NORTHEAST UTILITIES

Millstone Nuclear Power Station, Unit No. 3
Probabilistic Safety Study (PSS)

Request for Additional Information
Millstone Nuclear Power Station, Unit 3
Docket No.: 50-423

FIGURE 2.4-36
HATCH COVER DETAILS-
CIRCULATING WATER PUMPHOUSE
SERVICE WATER PUMP CUBICLE
MILLSTONE NUCLEAR POWER STATION
UNIT 3
FINAL SAFETY ANALYSIS REPORT

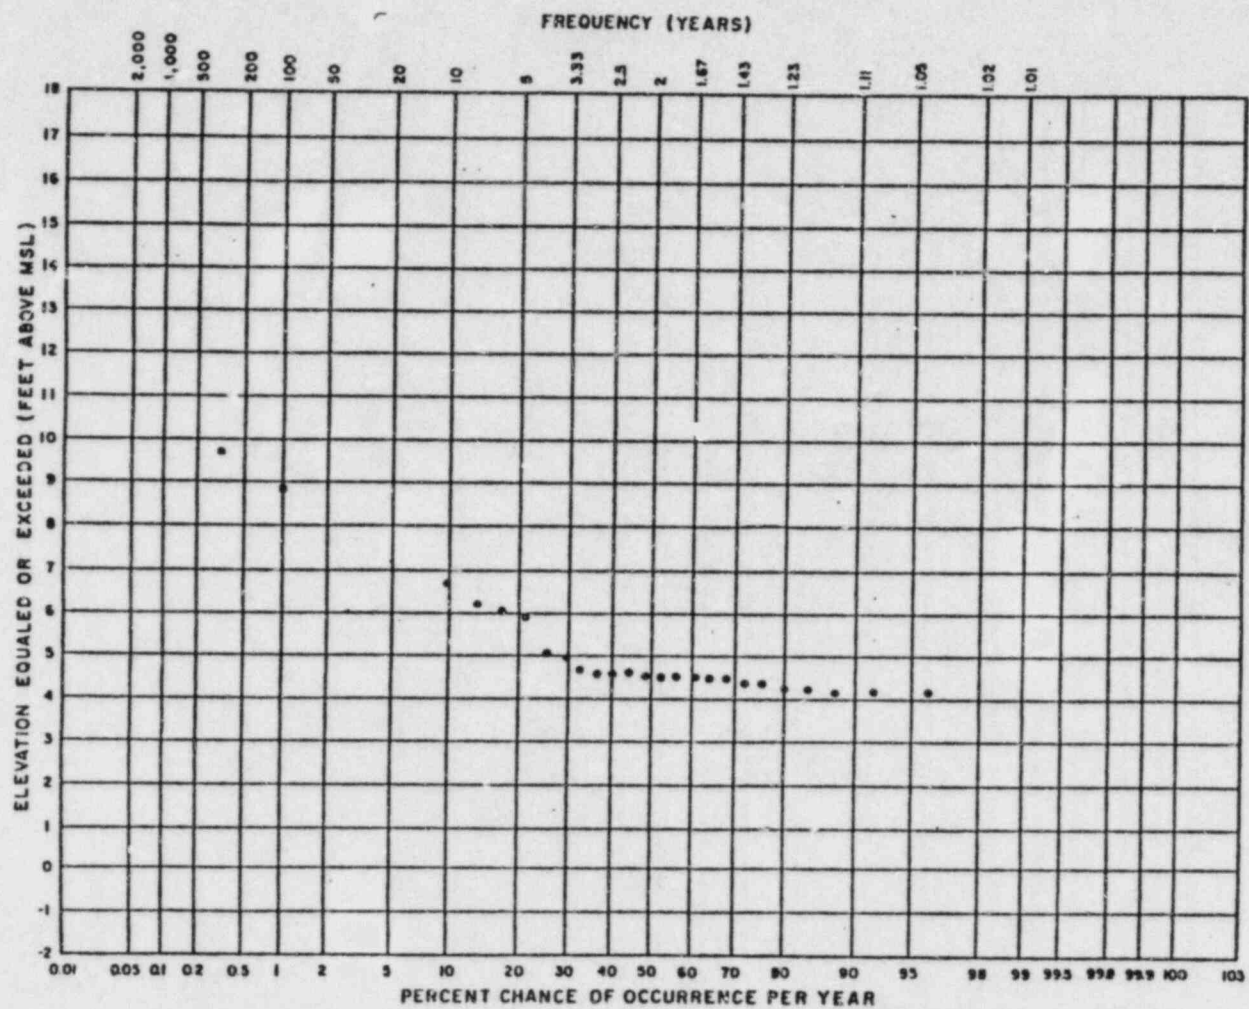
Question 720.92

The intake structure has hatches over the service water pumps. Each service water pump room has two service water pumps. We believe that failure of the two pumps in a pump room due to roof leakage is completely coupled.

- (a) What is the probability that the service water pump hatch seals leak during a severe storm and disable the pumps?
- (b) Estimate the common cause failure probability for loss of service water pumps in both rooms due to roof leakage.

- (a) Attached is Figure 2.4-36 from the FSAR depicting the hatch covers over the service water pumps. The covers consist of pre-cast concrete sections which weigh approximately 76,800 lbs. and rest on neoprene gaskets to produce a very effective sealing mechanism.

A highly conservative design bases type analysis was performed using Hydrometeorological Report No. 51 (HMR 51) and No. 52 (HMR 52) to determine the water surface elevation on the intake structure roof during a postulated PMP event. Based on the PMP guidance for rainfall depth-durations contained in HMR 52, a rainfall intensity of 70.4 in/hr for a five minute duration was used to perform this analysis. The results, which are tabulated in Table 2.4-12 of the FSAR, show that during this five minute event the water surface would exceed the elevation of the hatch seals by approximately 0.5 in.

The impact on the S.W. pumps of this 0.5 in. of water against the hatch cover for the five minute duration was evaluated as follows. As shown in Figure 2.4-36 the neoprene seals consists of continuous strips of dense neoprene, 2-in. wide by 3/4 in. thick, set in a 2 in. x 1/2 in. groove in the concrete. The probability of failure for this neoprene seal arrangement was assessed to be negligible, and any localized failure would not result in an infiltration of water which would endanger the service water pump cubicles. A postulated condition of no neoprene seal was considered to ascertain the impact on in-leakage. Due to the low head, 0.5 inches, and the resistance to flow that would be encountered along the concrete/concrete interface, in-leakage would be minimal using these conservative assumptions. Therefore, based upon a highly conservative analysis (the evaluation using the PMP event) the probability of in-leakage through the hatch seals is extremely small and need not be considered.

- (b) There are four separate hatches (2 ft. thick reinforced concrete slabs) on the roof of the building to allow major repairs to each of the four service water pumps. Two service water pumps are located in each of the two separate pump train cubicles. The joints between the slabs are sealed with an auto traffic grade sealer. With only routine maintenance of the structure roof, leakage of any type should not occur. In the highly unlikely event that one of the hatches developed a catastrophic type leak concurrent with a highly unlikely excessive rainfall event and drained water into one of the compartments the maximum credible effect would be
